HANNAH RIDGE AT FEATHERGRASS FILING NO. 5

CONSTRUCTION PLANS

HANNAH RIDGE AT FEATHERGRASS FILING NO. 5, 6 & 7 OVERLOT GRADING AND EROSION CONTROL PLAN			
DESIGNED BY	KRC	SCALE	DATE 10/12/18
DRAWN BY	KC	(H) 1" = 50'	SHEET 3 OF 11
CHECKED BY		(V) 1" = NA	JOB NO. 1116.05

HANNAH RIDGE AT FEATHERGRASS
FILING NO. 5
PUBLIC STORM SEWER PLANS

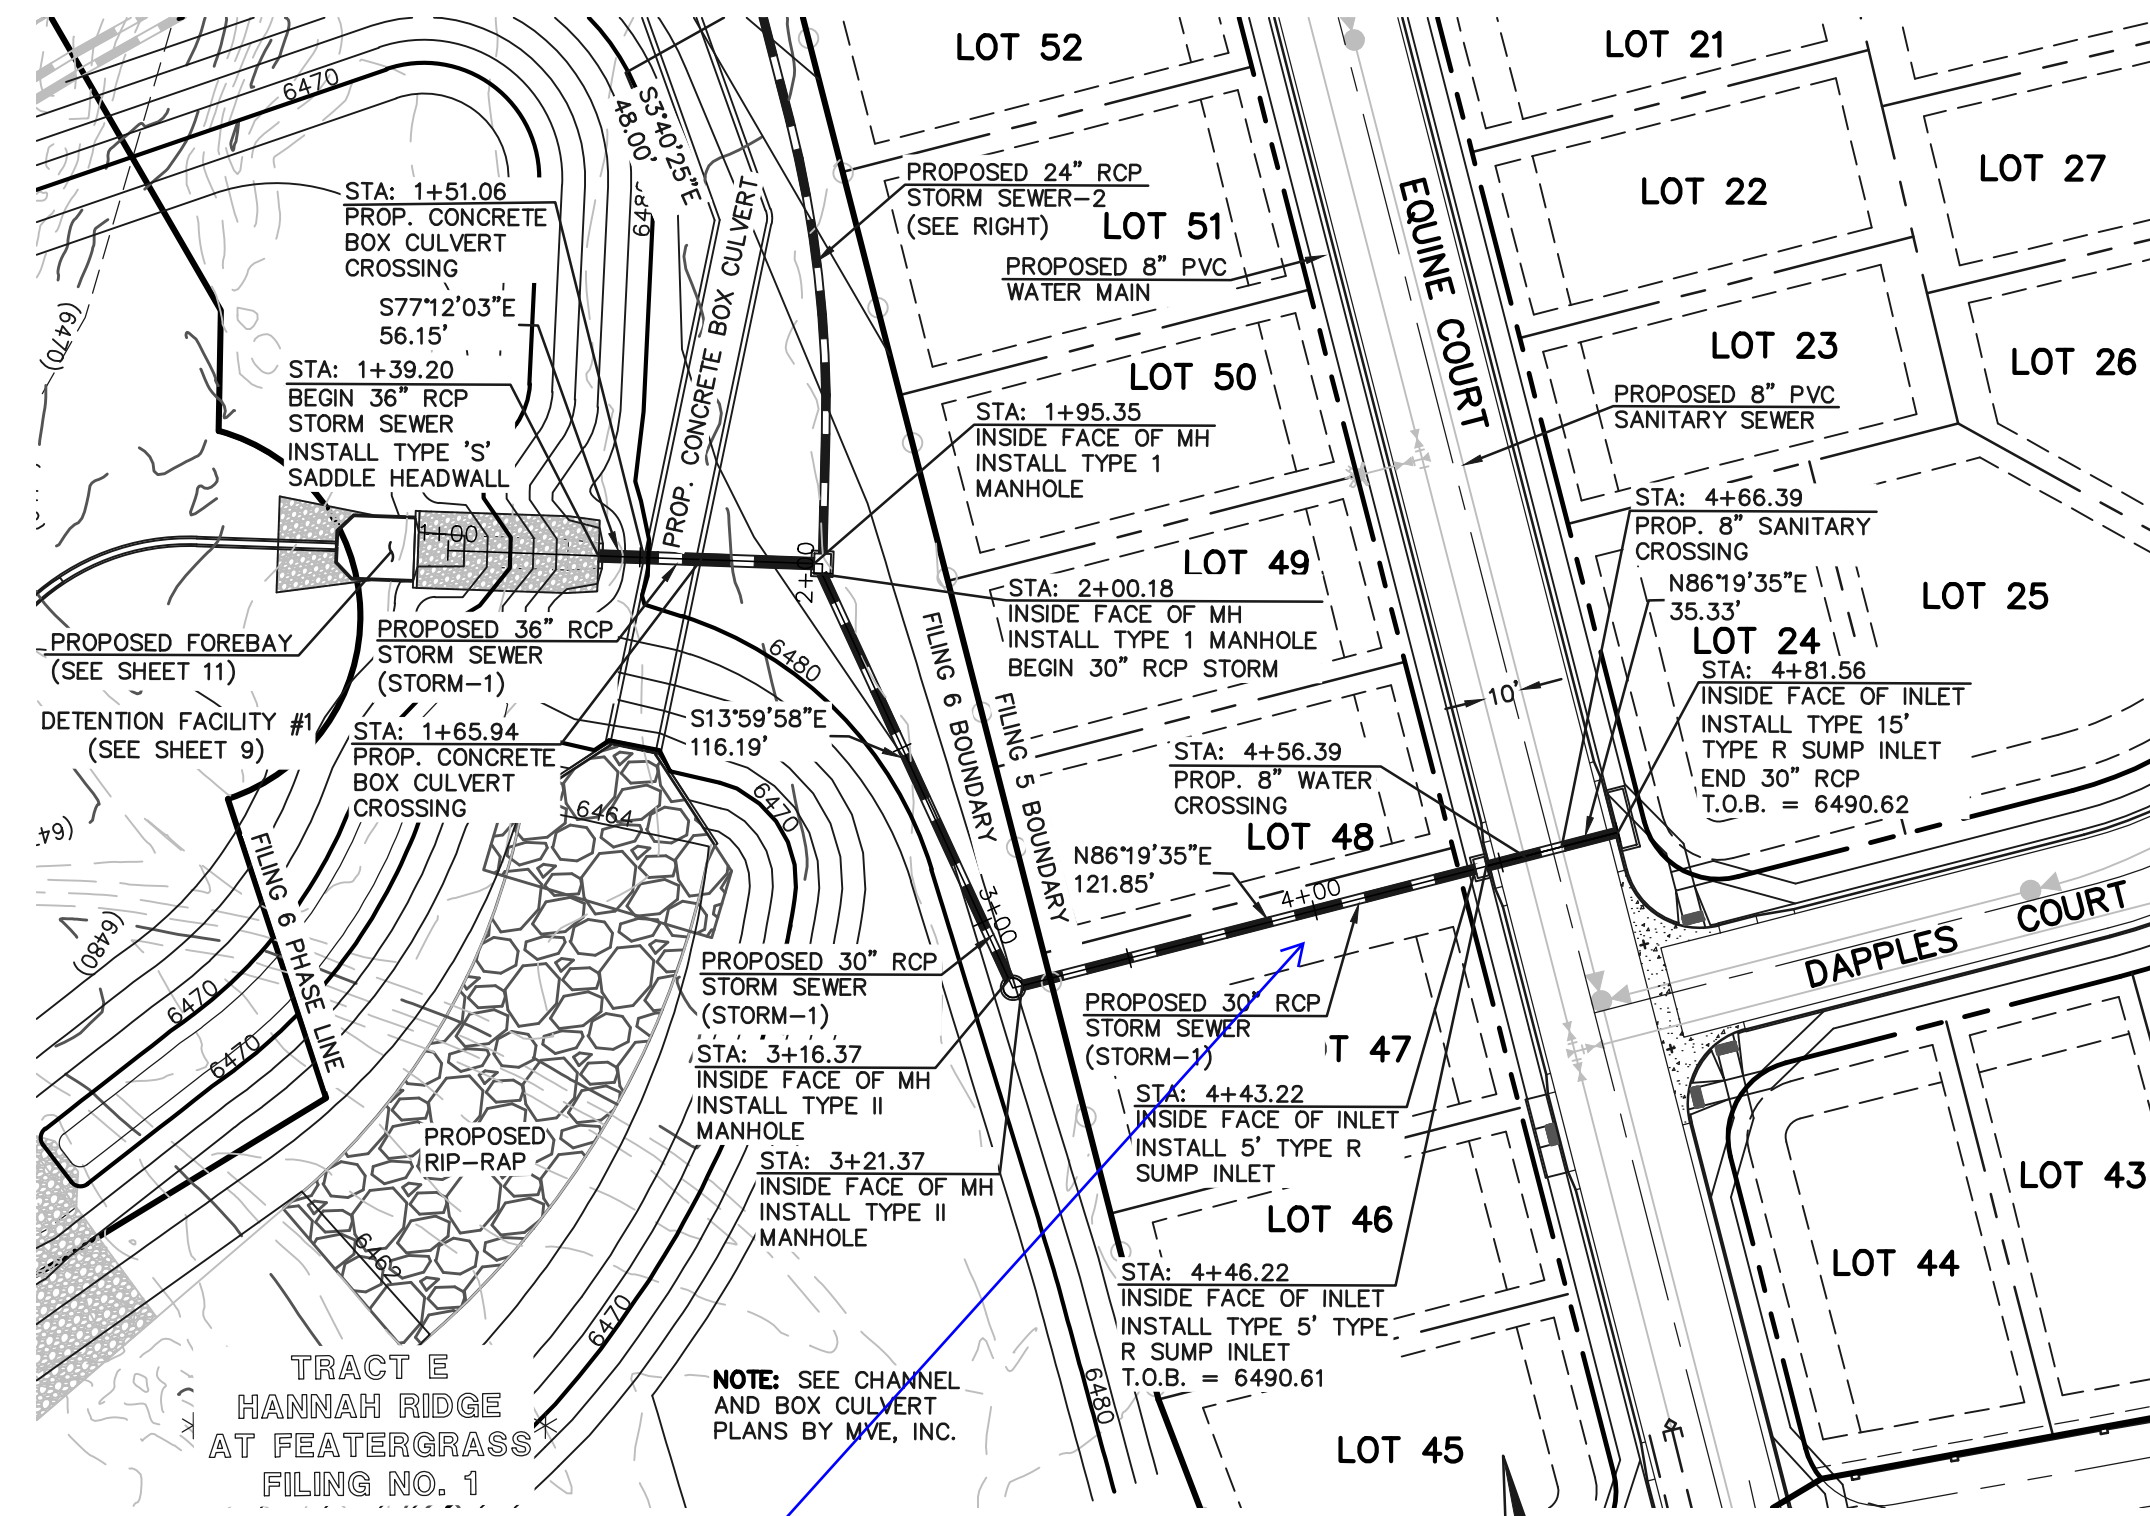
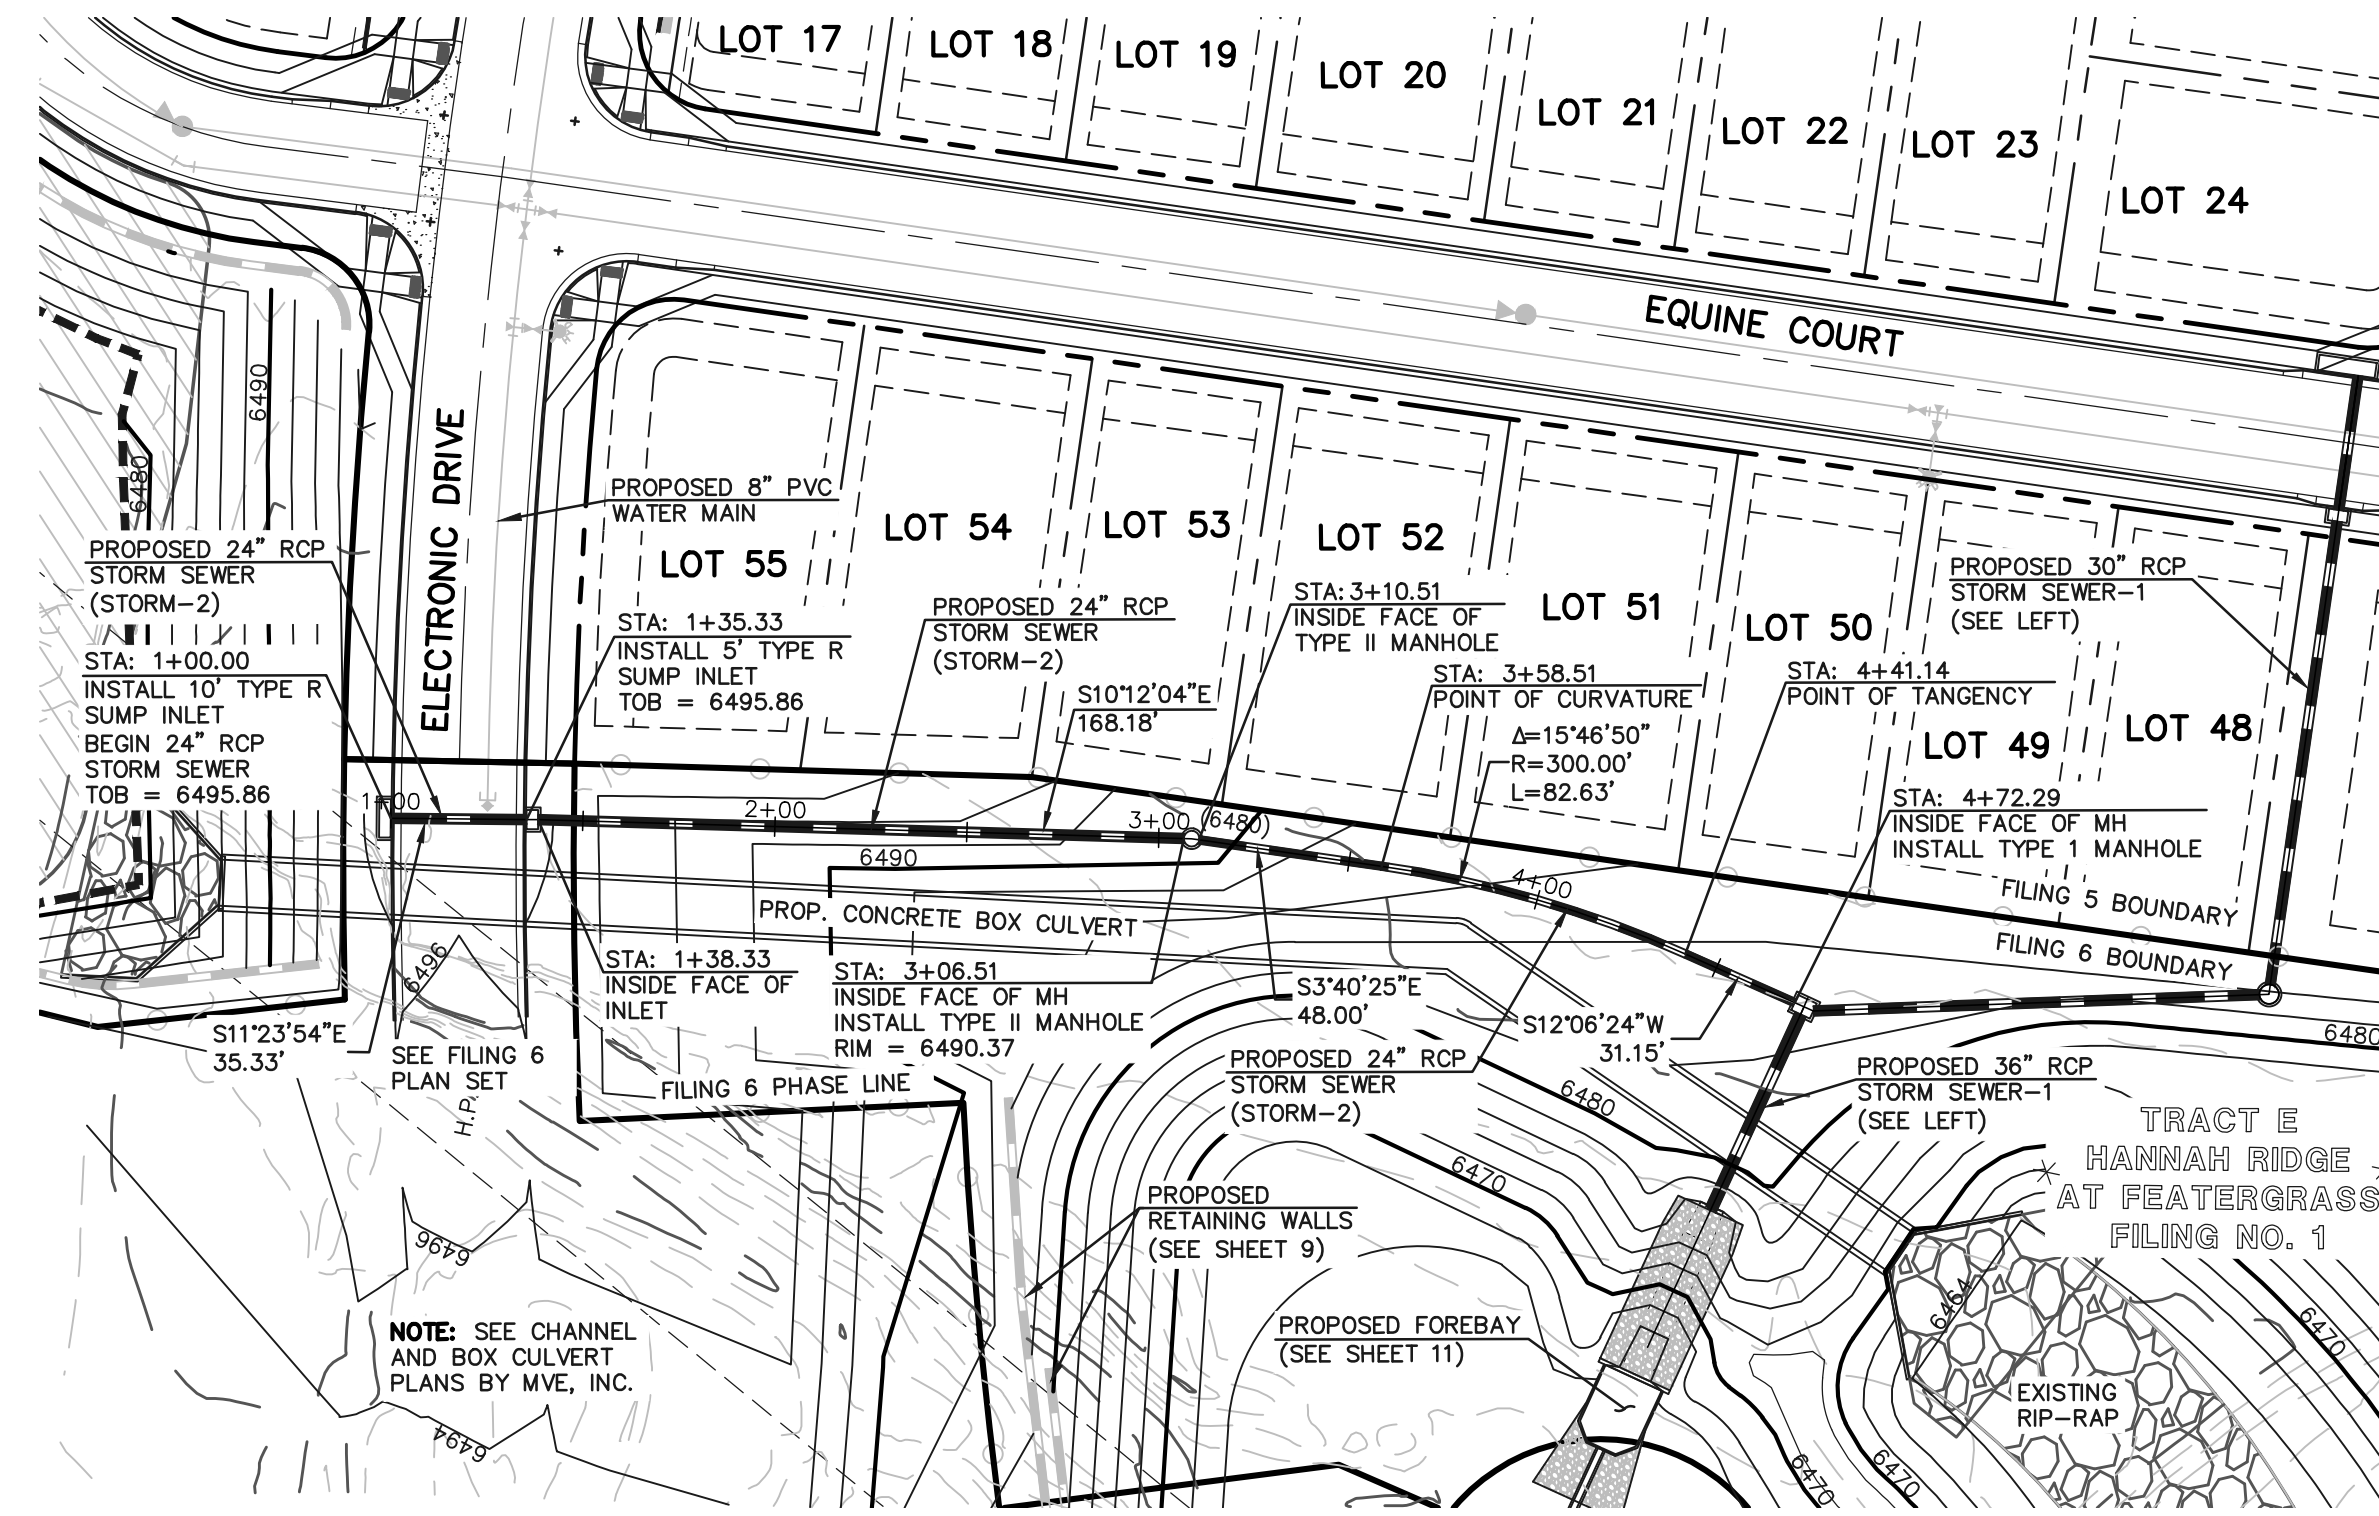
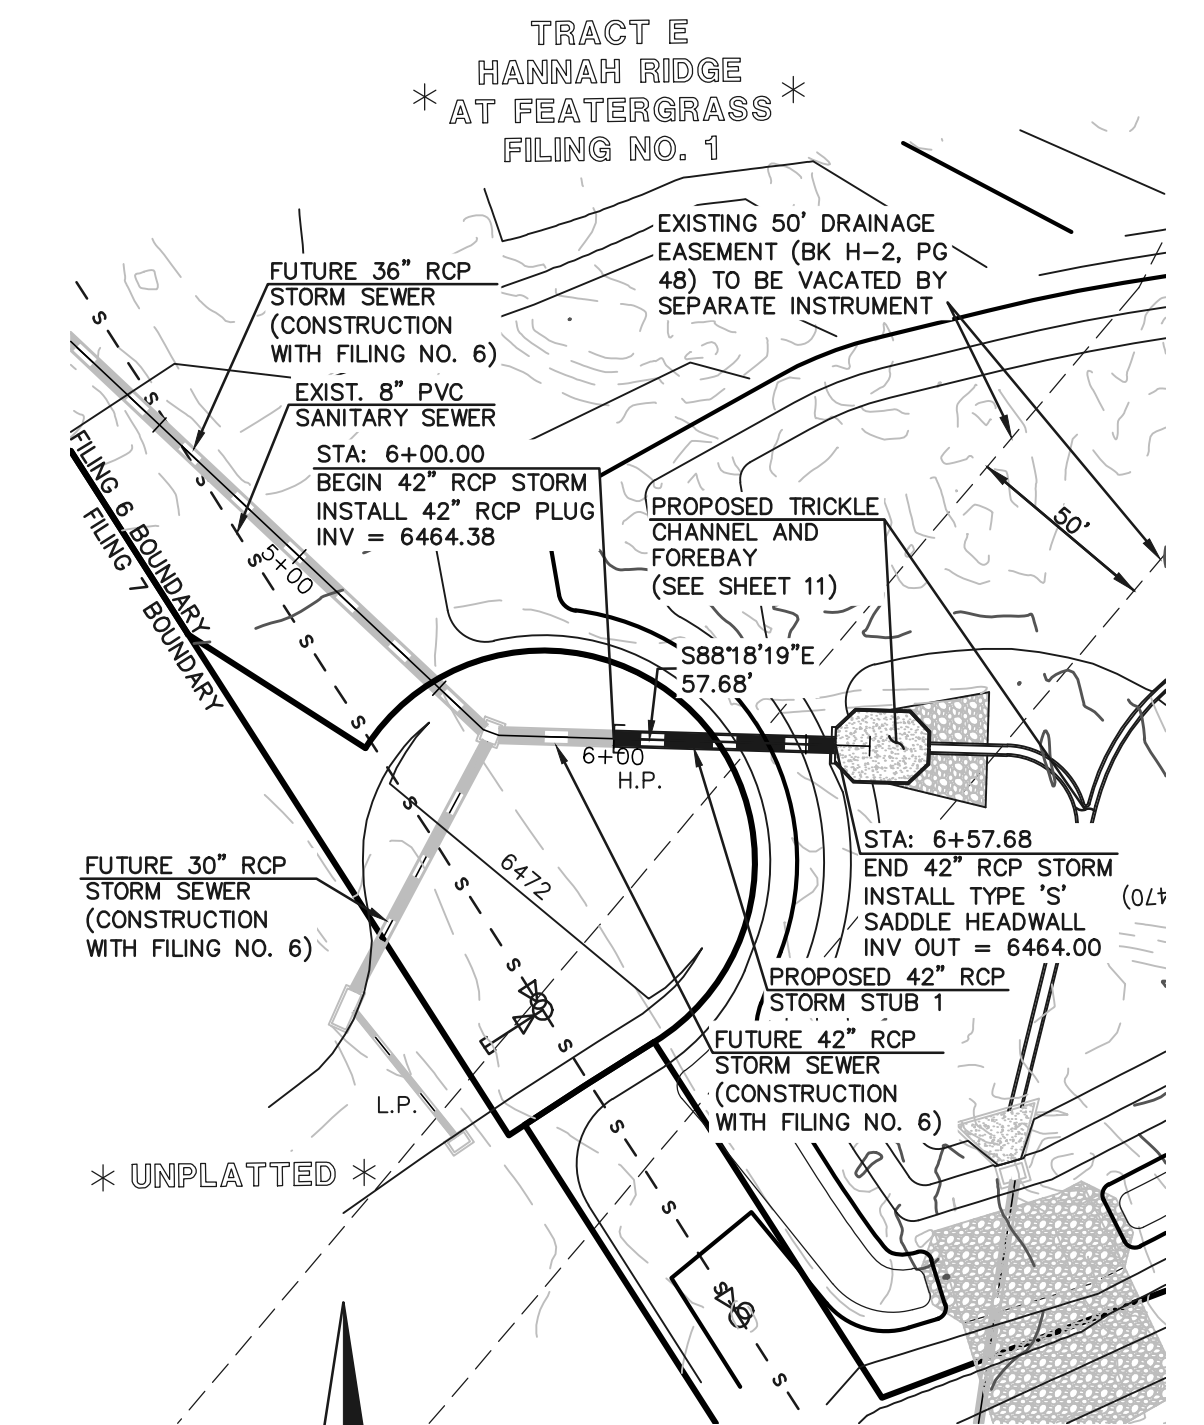
Call out Public Drainage easement.
